Access Compliance Report Public Rights-of-Way (Curb Ramps)

Main Street: W_NIOBE_AVE Cross Street: S_BROOKHURST_ST Location: SE

ADA ID: RPAT220202165609 Ramp Type: Type 4 - Parallel Initial Pass/Fail: Pass Overall Compliance: No Severity Score: 5

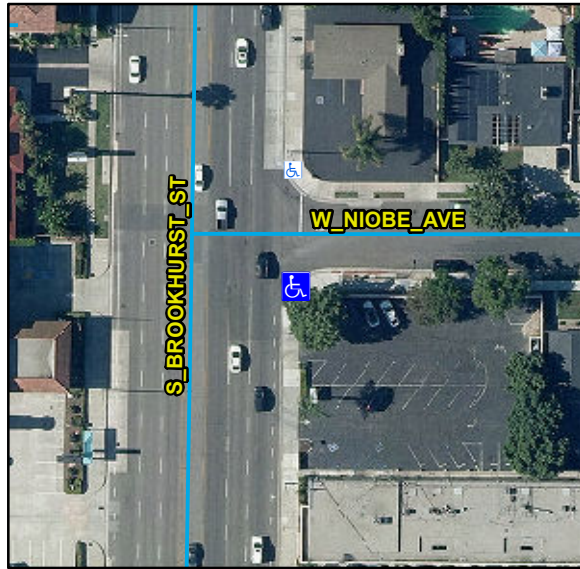
Crossing 1 Slope (%)	0.7		Crossing 2 Slope (%)	N/A
	Crossing 1 Cross Slope (%)	0.6		Crossing 2 Cross Slope (%)	N/A
Yes	Gutter Ponding	No	Yes	Curb Slope	5.4
Yes	Gutter Lip Height (in)	0		Road Run Slope (%)	N/A
No	Gutter Run Slope (%)	7.3		Road Cross Slope (%)	N/A
Yes	Gutter Cross Slope (%)	0.3	Yes	Perpendicular Joint Present	Yes
Yes	Overall Surface Condition	Acceptable			
	Cross Gutter Present?	No		Spandrel Present?	No
	Replace Cross Gutter?	N/A		Replace Spandrel?	N/A

Remove & Replace Gutter.
